DYRICK HILL WIND FARM LIMITED

RESPONSE TO OBSERVATIONS MADE ON DYRICK HILL WIND FARM PLANNING APPLICATION, CO. WATERFORD.

AN BORD PLEANÁLA PLANNING APPLICATION REFERENCE ABP-317265-23

April 2024

Figure 1: Male hen harrier carrying prey 8th May 2022 (17:02). HVPs location provided to show coverage of the area (shown in hatching) during hinterland surveys.

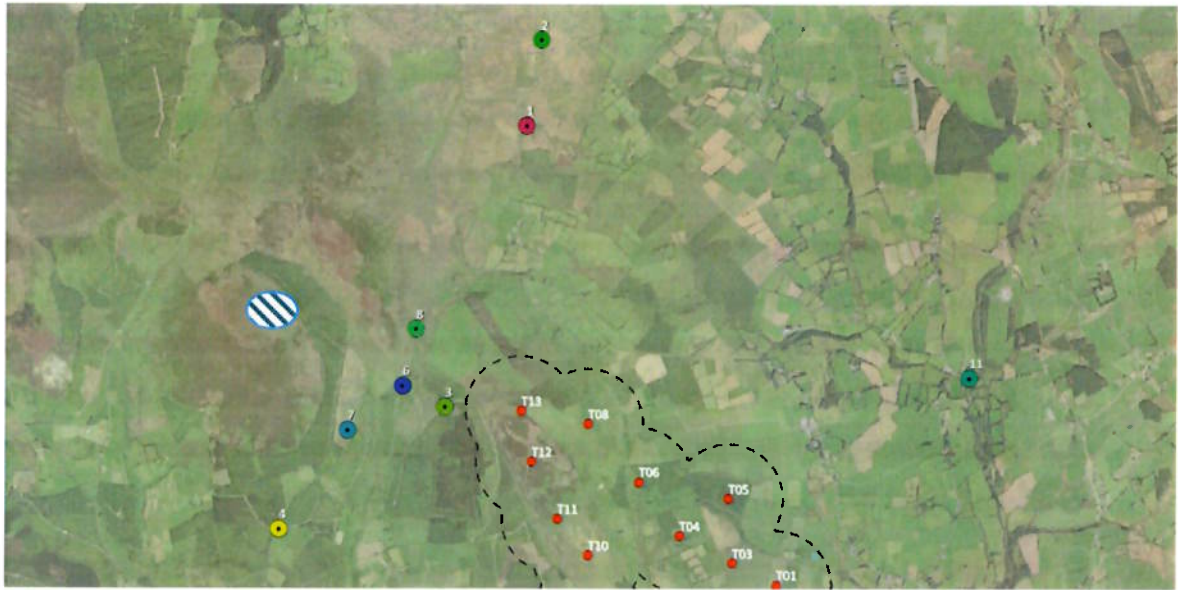
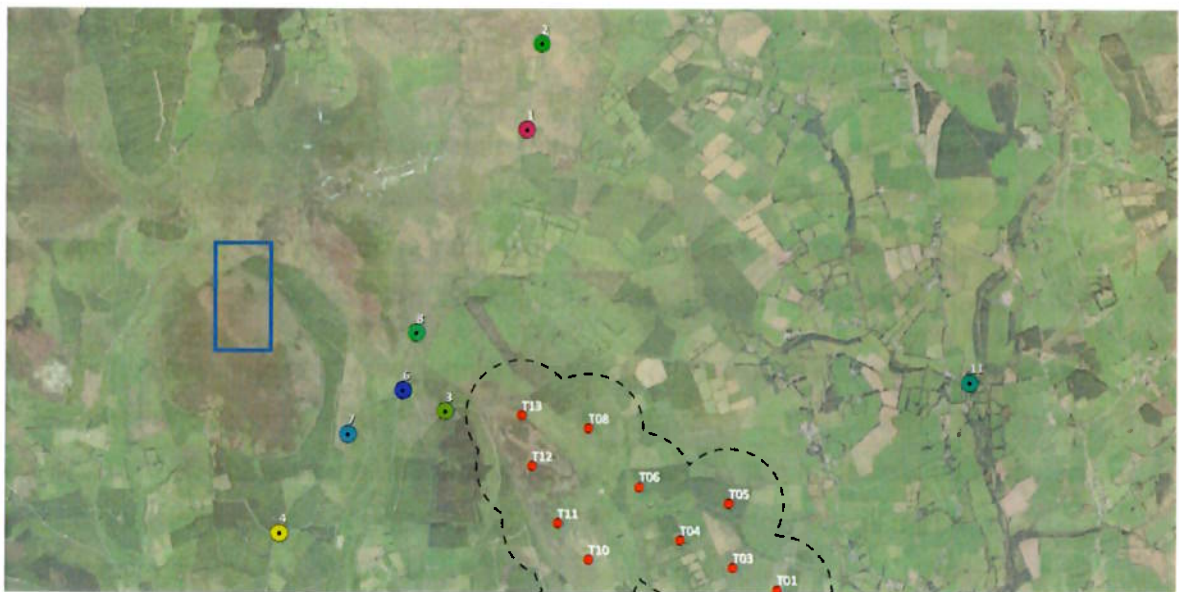
The Department considers the open area on Broemountain to be good quality habitat for hen harriers, as was indicated by their repeated breeding there up until 2019 and producing 4/5 chicks annually (Allan Mee, pers, com.). Some small habitat change has taken place in recent years but should be seen in context with other adjoining upland areas and remains entirely suitable foraging and nesting habitat. Such changes are very minor compared to the Development and are likely temporary as agricultural regulation application and incentives change. As evidenced by the 2015 National Hen Harrier Surveys, the Broemountain area makes up the eastern extant of a larger unit of important hen harrier habitat where in 2015 five breeding harrier pairs nested. Five pairs constituted between 3.2 and 4.8% of the national population of the Annex I bird species. The survey also indicated the national population had declined by 8.7% since the last survey in 2010. This area was not selected as a Special Protection Area but to provide context of the value of this site, criteria used for SPA designation included if used regularly by 1% or more of the all-Ireland population of a species listed in Annex 1 of the Birds Directive in any season. the Knockmealdown area significantly exceeds this threshold. Article 4(4) of the European Birds Directive specifies that Member states shall strive to avoid pollution or deterioration of habitats and in case C-374/98a the European Court of Justice held (paragraph 47) that "it is clear, therefore, that areas which have not been classified as SPAs but should have been so classed continue to fall under the regime governed by the first sentence of Article 4(4) of the Birds Directive" .

Knockmealdowns held five confirmed breeding pairs of hen harrier, one of which was within the Development site, one within 0.5km and one within 3km. The Department does not accept the EIAR assessment (Table 7.22) that harrier habitat on the site is highly degraded and 'deemed unlikely to be suitable for breeding' or that it is sub-optimal for foraging, nor does the Department accept conclusions drawn that only 11.17ha of suitable habitat will be lost through the development. The EIAR has not mentioned or included in its evaluation the importance of nearby young pre-thicket forestry plantation which is also suitable breeding and foraging habitat supporting the adjoining open habitat. We are aware that hen harrier nested in young forestry at the Broemountain site in 2016 and a nearby site (0.5km) in 2019 and both pairs regularly foraged over pre-thicket forestry as well as heather moorland and grass moorland at the site (A. Mee pers. obs.).

Over the more than two years of monthly hinterland surveys there were a total of six sightings of hen harrier. The sightings were recorded on four dates between 17th October 2021 and 8th May 2022, all involving sightings of single hen harrier, four of which were seen hunting and two of which were seen carrying prey. All sightings, bar one, were of adult males.

The two sightings of a male hen harrier carrying prey were both recorded on the 8th May 2022 from HVP6. The sightings occurred within an hour of each other and are considered to be the same individual on both occasions. The first sighting was made at 17:02, lasting for 70 seconds, with a flight height of between 20-30m heading in a north-northwest direction away from the HVP. The second occurred at 17:52 a male HH carrying prey which flew off in a northerly direction over Knocknasculloge. The significance of these sightings in term of potential nesting behaviour was noted at the time of the surveys and HVP surveys were undertaken monthly from June to September at these HVPs to assess potential nesting activity in this area but yielded no further observations of hen harrier. The timing and details of hinterland surveys are provided in Appendix 7.3 Volume of the EIAR.

Figure 3: Locations of archaeological sites subject to preservation orders in relation to the Proposed Development (turbine locations indicated in red)

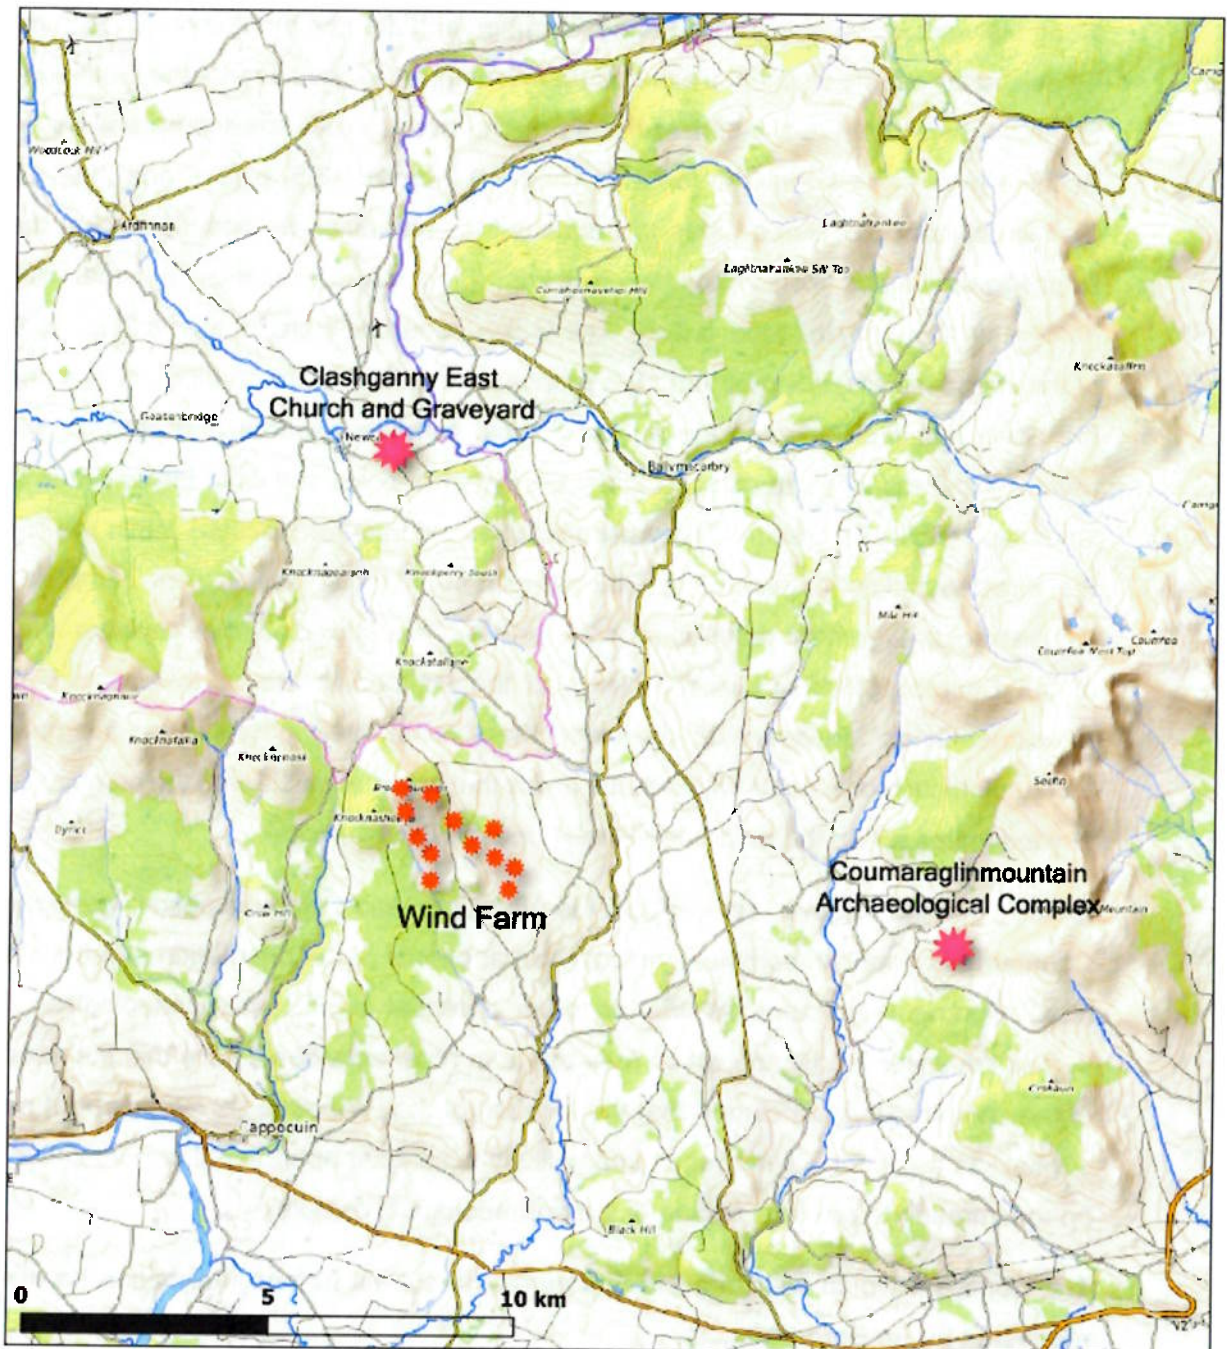
Graveyard at Clashganny East Co. Tipperary (Preservation Order No 4/97) and an Archaeological Complex at Coumaraglinmountain, Co. Waterford (Preservation Order No 4/1996) (see Figure 3 below).

This preservation order encompasses a Bronze Age complex which contains 116 individual, inter-related sites within an area measuring c.2km by 2km the south side of the Araglin Valley and its nearest section is located c.8km to the east of the Proposed Development (See Figure 3 below showing the location of this complex in relation to the Proposed Development). As stated in the EIAR The sites within the complex comprise three cairnfields, three field systems, four prehistoric enclosures, twenty-three hut sites, twelve standing stones, a stone pair, two possible stone rows, thirteen cairns, four ring-cairns, seven cairn circles, nine kerb circles, a ring-barrow, a megalithic structure and an embanked enclosure (SMR WA014-033002- to WA014-033035. (inclusive) and WA023-066001- to WA023-066084-(inclusive)). The sites are located within third-party lands and no heritage centres or formal access routes to their locations are present. As noted by the NMS, c.40% of the overall footprint of the complex lies within 10km of the Proposed Development. The NMS also note that, while the EIAR does assess potential indirect impacts on three archaeological monuments within the complex, which comprised monument types with potential visual alignments across the wider landscape, these were considered in isolation and not as part of the wider inter-related complex which may be vulnerable to operational/cumulative indirect impacts on its setting. As noted in Table 13.6 of the EIAR, the review of the recorded monuments with potential visual alignment attributes within the complex revealed that none were directly aligned towards the location of the Proposed Development.

Based on the above review of the location and archaeological context of the Coumaraglinmountain complex, including an appraisal of the orientation of monuments with ritual alignment attributes as well as other potential significant archaeological sightlines across the wider landscape which may relate to ritual activities held within the internal area of the complex, it is concluded that the location of the Proposed Development at a distance of 8km+ to the west will not result in any likely significant operational or cumulative impacts on the immediate or wider setting of the archaeological complex.
